INDIANA DEPARTMENT OF TRANSPORTATION

AGENDA

October 21, 2010 Standards Committee Meeting

RE: Agenda for the October 21, 2010 Standards Committee Meeting

706-CBRT-01 BRIDGE RAILING TRANSITION WBC OR TBC DETAILS AT END BENT (DRAFT)

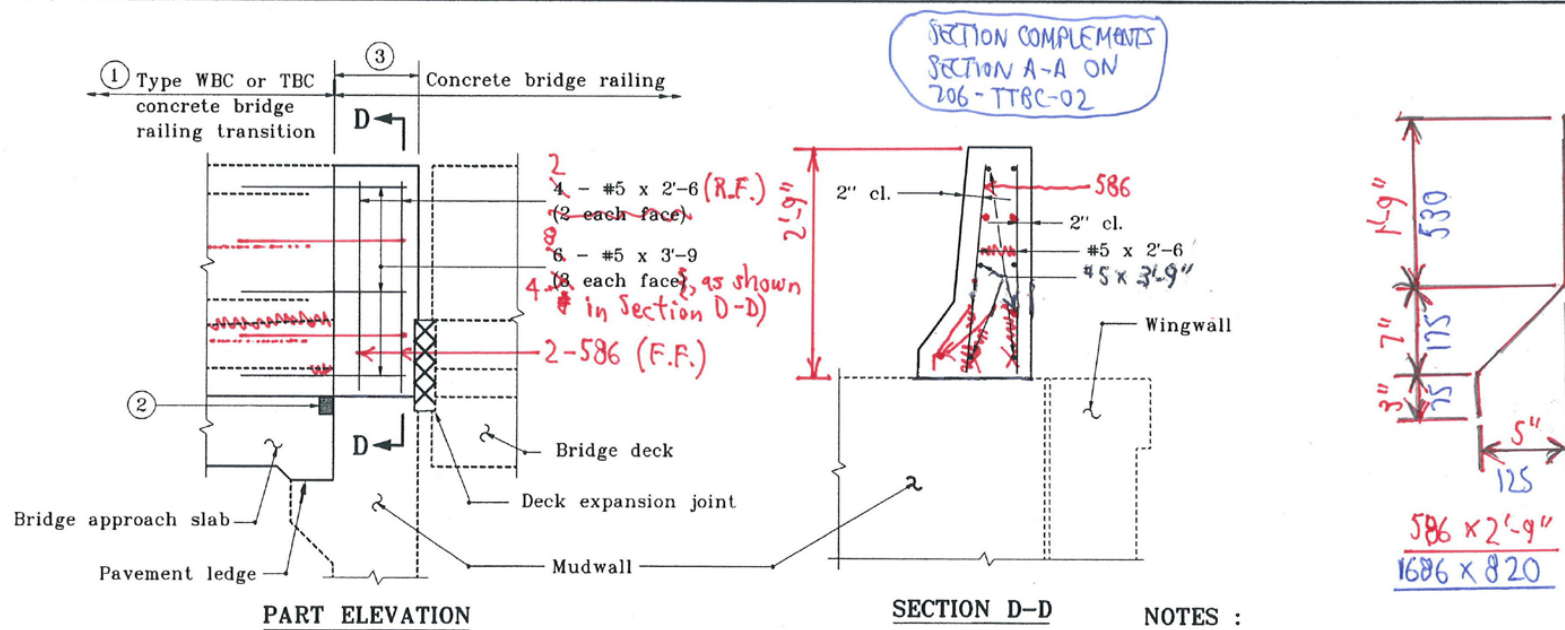
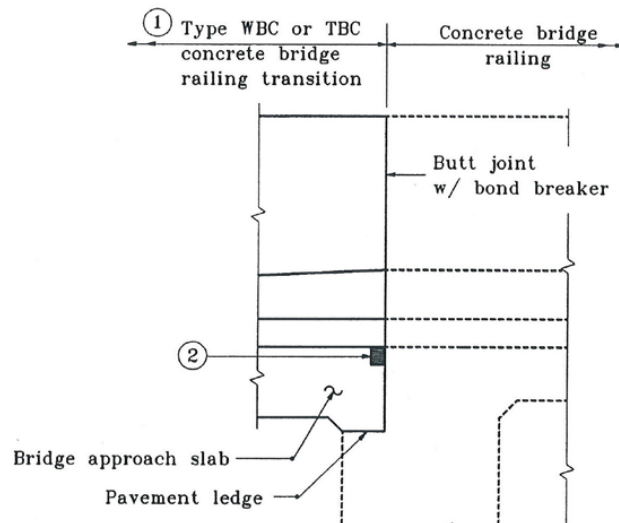
PROBLEM(S) ENCOUNTERED: There are no standard details for the section of concrete bridge-railing transition above the mudwall for the TBT, or truck-height, transition. The existing such standard details for the WBC or WBT, or common-height transitions, show a reinforcement pattern which does not match that in the main portion of the transition.

PROPOSED SOLUTION: Develop standard details for the mudwall portion of the TBT transition, and modify the existing details for the WBC and TBC transitions, so that the reinforcement pattern in the mudwall portion matches that in the main portion.

APPLICABLE STANDARD DRAWINGS: Revise 706-CBRT-01 for WBC and TBC transitions; add new 706-CBRT-03 for TBT transition; change existing 706-CBRT-02 to -04 and 706-CBRT-03 to -02 for drawings-series-order logic.
